### **CERTIFICATE OF APPROPRIATENESS**

**Proposal:** Alteration—Installation of solar panels without a COA or city permits.

July 29, 2021 HPO File No. 2021\_0163

# **ITEM E20** 215 Bayland Ave Woodland Heights

PV-1

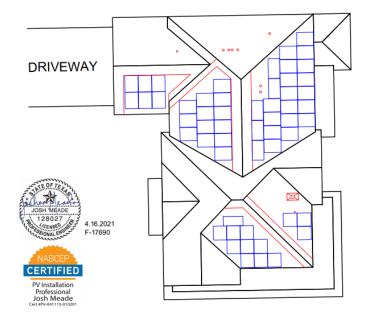
Recommendation: Approval with conditions: Staff recommends issuance of a COR to remove the solar panels located on the front south location and the front east location.

S	D	NA		S - satisfies D - does not satisfy NA - not applicable
	$\boxtimes$		(1)	The proposed activity must retain and preserve the historical character of the property; Solar panels are visible from the right of way, therefore, do not meet Criteria 1.
$\square$			(2)	The proposed activity must contribute to the continued availability of the property for a contemporary use;
